Project	<b>IEEE 802.16 Broadband Wireless Access Working Group</b> < <a href="http://ieee802.org/16">http://ieee802.org/16</a> >
Title	Enhancement for rate 2, 4-transmit antenna STC
Date Submitted	<b>2005-1-10</b>
Source(s)	Jianzhong (Charlie) Zhang, Kiran Kuchi, Anthony Reid Voice: 972-374-0958, 972-374-1862 Fax: 972-894-5937 <a href="mailto:charlie.zhang@nokia.com">charlie.zhang@nokia.com</a> , <a href="mailto:kiran.kuchi@nokia.com">kiran.kuchi@nokia.com</a>  Nokia 6000 Connection Drive Irving, TX 75039
Re:	IEEE 802.16e D5 Draft
Abstract	Proposes an enhancement to rate 2, 4-transmit antenna space time code
Purpose	To incorporate the changes proposed here into the 802.16e D5 Draft.
Notice	This document has been prepared to assist IEEE 802.16. It is offered as a basis for discussion and is not binding on the contributing individual(s) or organization(s). The material in this document is subject to change in form and content after further study. The contributor(s) reserve(s) the right to add, amend or withdraw material contained herein.

## Enhancement for rate 2, 4 transmit antenna STC

Figure1: FER performance of circulated matrix B

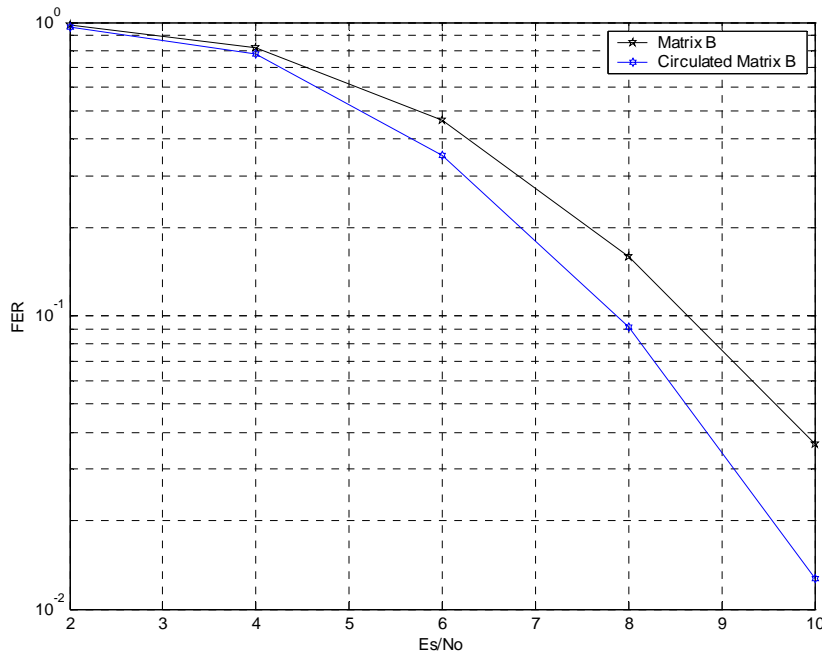
In Figure 1, we compared the FER performance of the circulated code to Matrix A for 4 Tx and 2 Rx case in for Ped A channel, rate 1/2 convolutional code, QPSK modulation using LMMSE receiver. We notice an increase in coding gain up to 1.0 dB. Similar gains are expected for other modulation and coding modes.
